**STAFF REPORT**  
**(Final Plat)**

**CASE NUMBER:** S/D 96-48 AUBURN HILLS POOL HOUSE ADDITION

# UTILITY PLAN

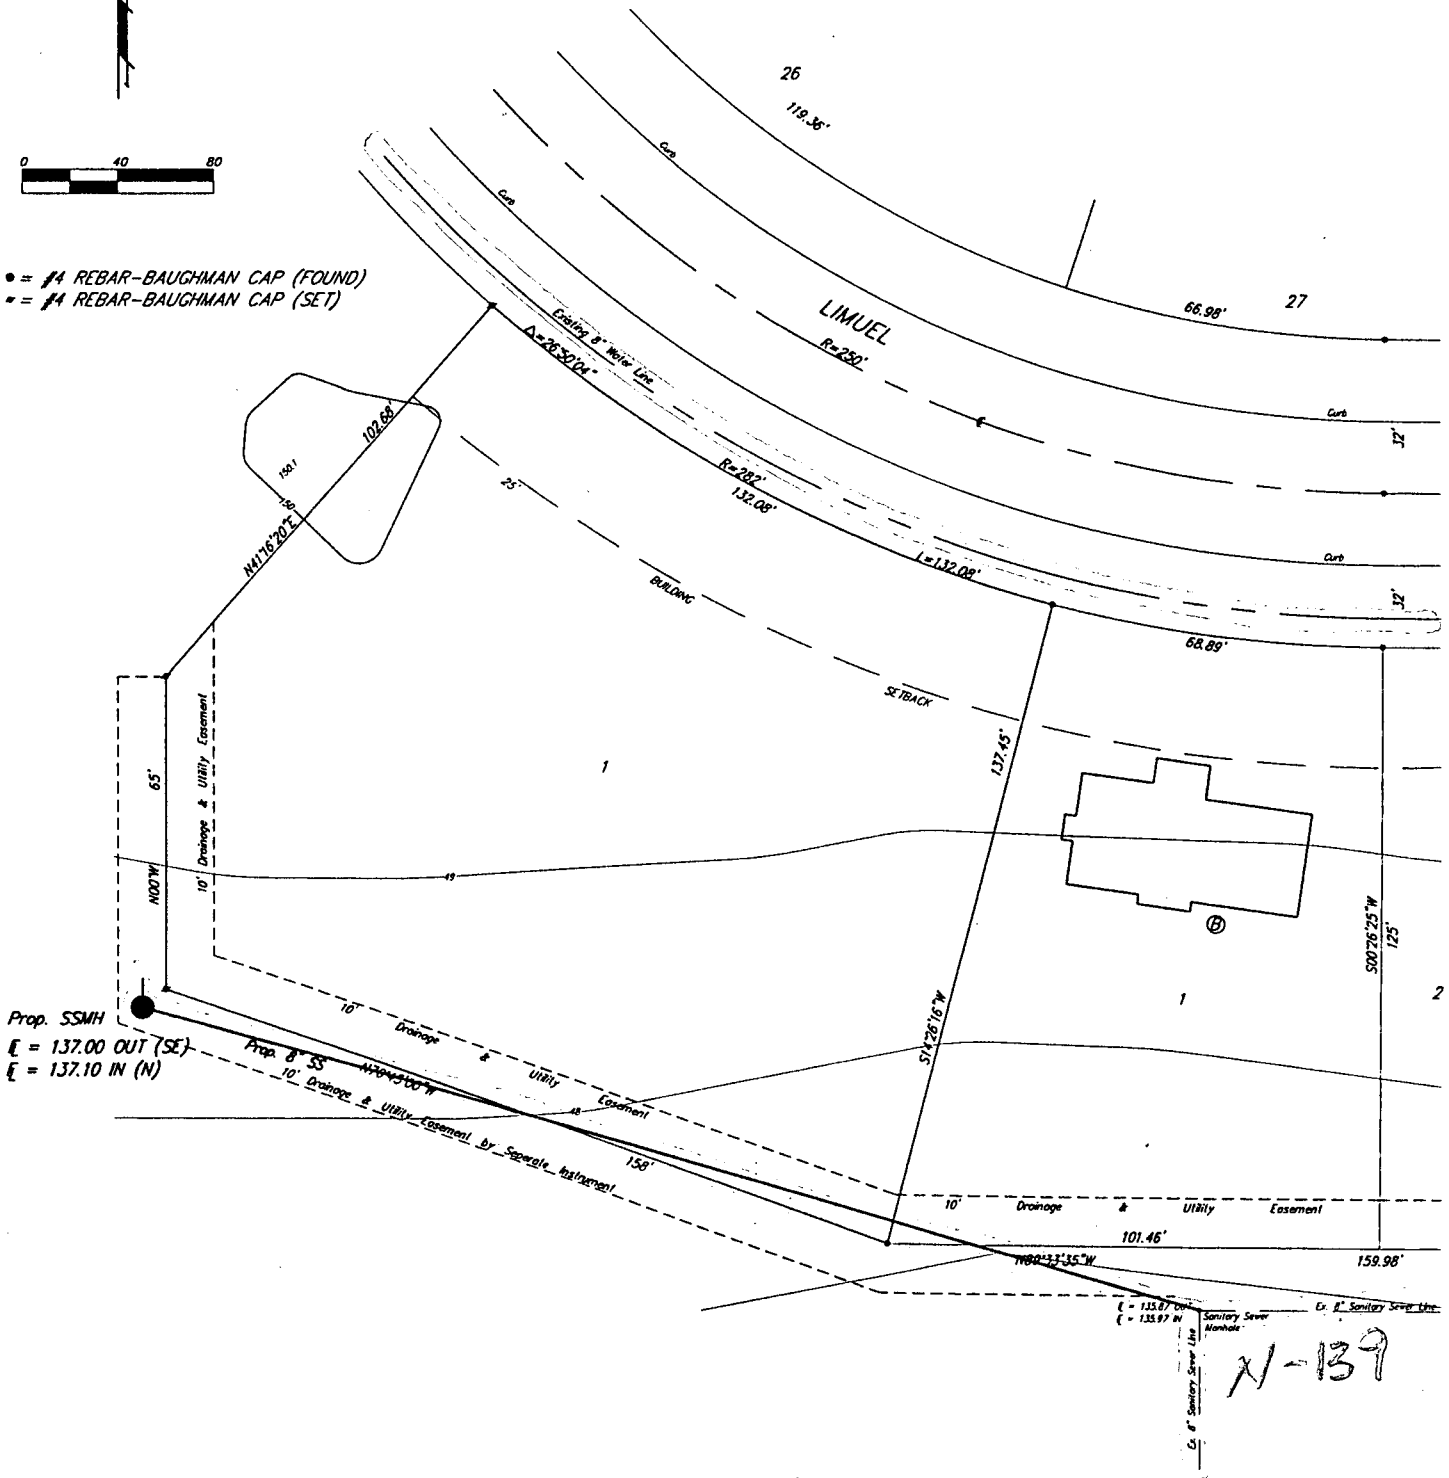
- C. The applicant shall guarantee the extension of sanitary sewer to serve the lots being platted.
- D. The applicant shall guarantee any drainage improvements required by the platting of this property.
- E. If improvements are guaranteed by petition, a notarized certificate listing the petitions shall be submitted to the Planning Department for recording.
- F. On the final plat tracing, Deputy shall be deleted from the City Clerk's signature line.
- G. As noted by the platting binder, a mortgage is behind held by the State Bank of Colwich. This party needs to either be shown as a signatory on the final plat tracing or a release of the mortgage submitted to Planning.
- H. A number of easements are listed in the platting binder. If these easements are being replatted, proper reference to KSA 12-512(b) should be noted on the plat. In any case, the applicant's

- I. The applicant shall install or guarantee the installation of all utilities and facilities which are applicable and described in Article 8 of the MAPC Subdivision Regulations. (Water service and fire hydrants required by Article 8 for fire protection shall be as per the direction and approval of the Chief of the Fire Department.)

- M. The representatives from City Engineering should be prepared to comment on the status of the applicant's drainage plan. Engineering also needs to indicate if the minimum building pad elevation is acceptable.
